Technical Service Bulletin

96 Warning message in DIS: "Key not In vehicle" or "Remote key not recognized"

96 15 03 2039108/3 November 9, 2015. Supersedes Technical Service Bulletin Group 96 number 14-90 dated December 5, 2014 for reasons listed below.

Model(s)	Year	VIN Range	Vehicle-Specific Equipment
Q3	2015 - 2016	All	Not Applicable

Figure 1. The front storage compartment in the center console (Number 17).

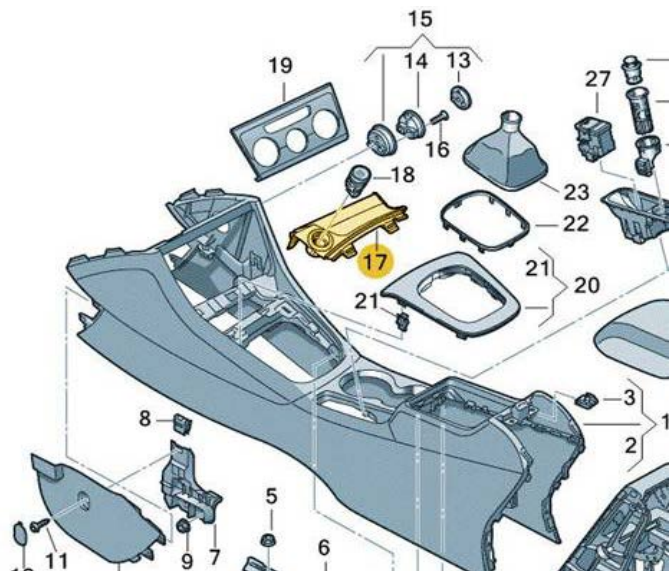
1. Remove the front storage compartment according to the Elsa Repair Manual (Figure 1).

Figure 2. Zip tie with holder.

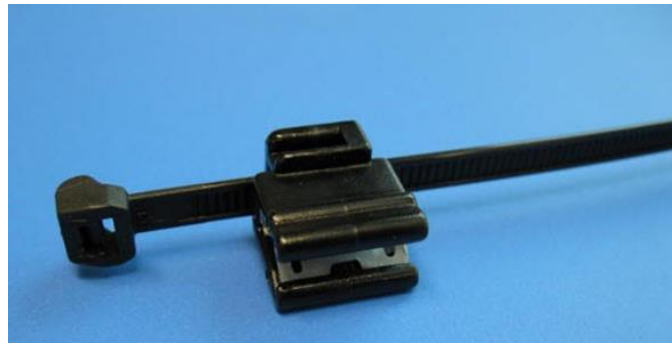
2. Remove the climate control module according to the Elsa Repair Manual.
3. Remove Aerial 1 for Access and Start Authorization (R138).
4. Change the routing of the cable for the Access and Start Authorization button and for Aerial 1. The routing of the wiring harness for the shift gate must also be modified.
5. Using a zip tie with holder (**3D0 971 838 M**) (Figure 2), turn the zip tie by 90° (Figure 3).

Figure 6. Zip ties with adhesive retaining plates installed on Aerial 1.

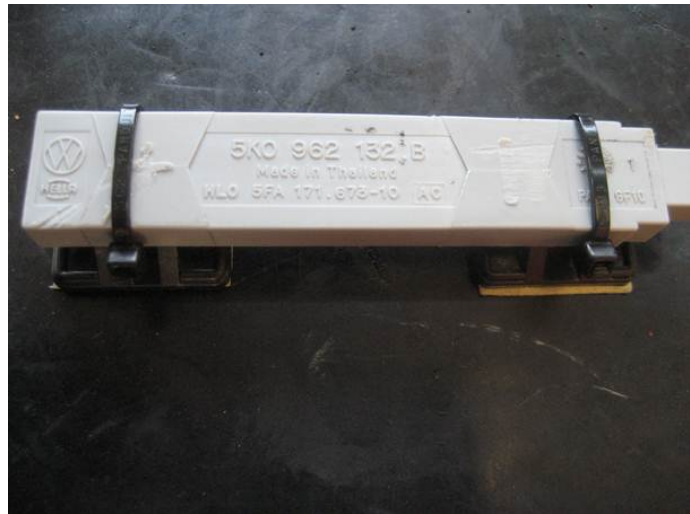
8. Attach zip ties (N 020 904 8) and the retaining plates for zip ties (000 971 010 A) as shown (Figure 6).

Figure 7. Mounting surface on HVAC ducting to be cleaned.

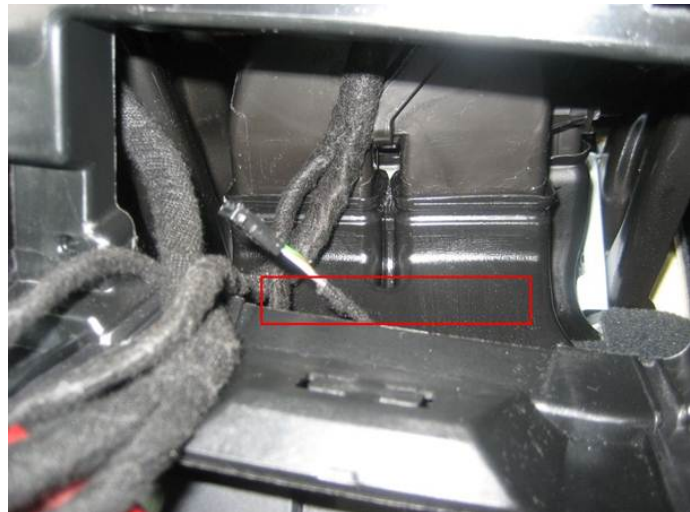
9. Prepare the mounting surface by cleaning the marked area with cleaning solution (D 009 401 04) (Figure 7).
